INDESIT company

Model type:
WITE87EU

Commercial code:
F034269

1140960 Exploded views

n1040345: Replacement of drum lock button TL EVOII.

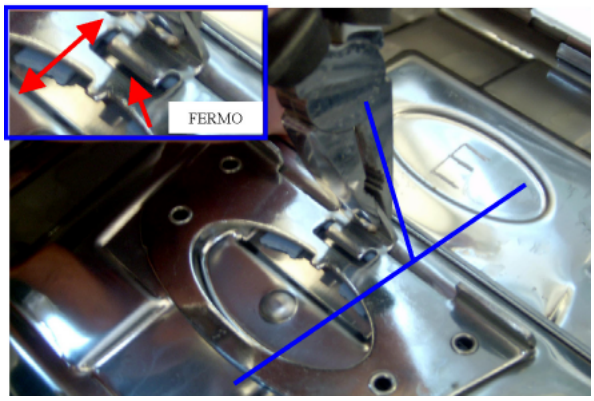
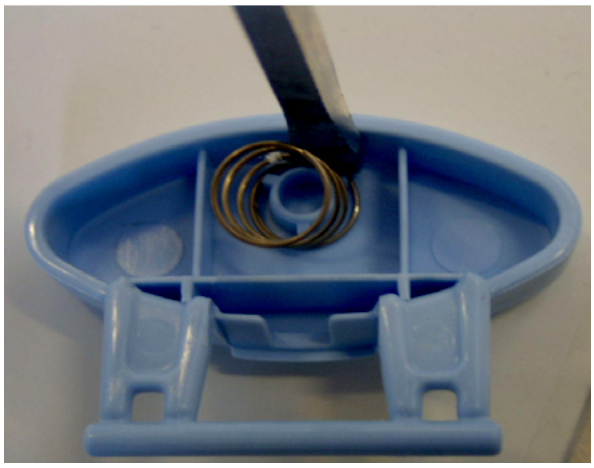
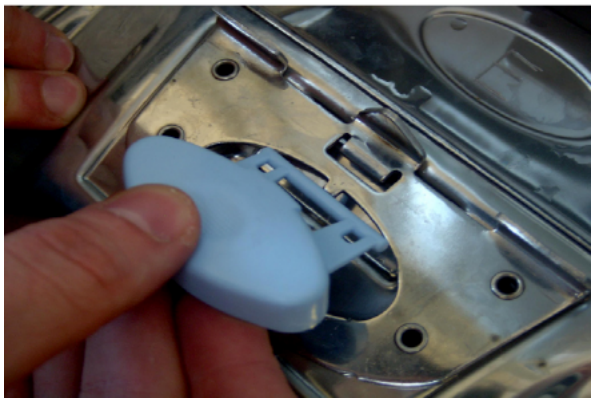
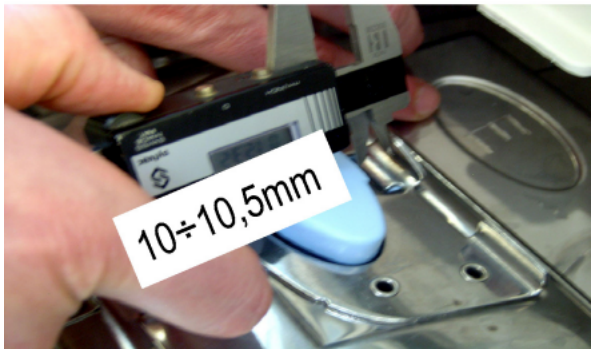
Tools and material needed: pliers, screwdriver, gauge, spring P/N Sat 114989, button P/N Sat 114990.

1) turn the central tip of the catch in the direction shown (FIG.1);

2) bring the tip to a vertical position and ensure that the broken button is disengaged from the catch restraint and can be removed (FIG.2);

3) remove the remaining part of the button with the aid of a screwdriver, taking care not to scratch the doors (FIG.3);

4) pre-assemble spring to button (FIG.4);

5) insert button between catch and door (FIG.5);

6) bring the button into position and arrange the spring in its location in the door (FIG.6);

7) turn the central tip of the catch in the direction shown to return it to its starting position (FIG.7);

8) check the distance between button and catch (FIG.8);

9) check correct operation of the button when opening and closing the doors (slight inclination errors of the catch can result in

faulty closing of the doors) (FIG.9).

n1040382: Drain pump with bayonet-style filter - top Loading Brembate

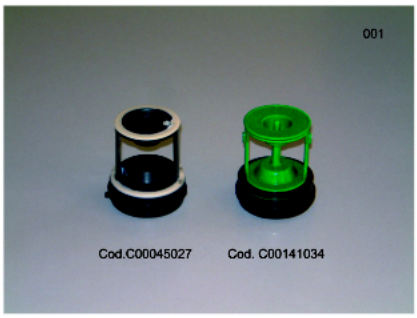
From serial no. 51021.0001 a new drain pump with bayonet-style filter has been installed on all top loading washing machines manufactured in Brembate.

New parts:
C00141862 - Drain pump
C00141034 - Pump filter kit

Premodification parts:
C00111409 - Drain pump
C00045027 - Pump filter kit

The new parts can be used instead of premodification ones.

N1040404FIG1

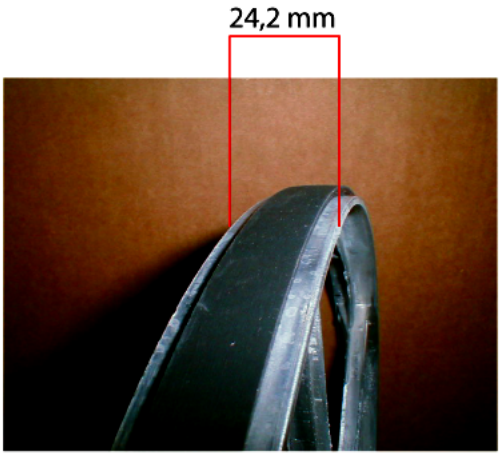
n1040404: New pulley installed on top loading washing machines up to 1000RPM (NO tub lock)

From serial no. 51202.0001 the pulley track has been widened from 21.2mm to 24.2mm (see picture N1040404FIG1).

new pulley
C00142832 - D280 24.2 mm track

Premodification pulley
C00083912 - D280 21.2 mm track

The new pulley can also be used on premodification versions of the models referred to in this release.
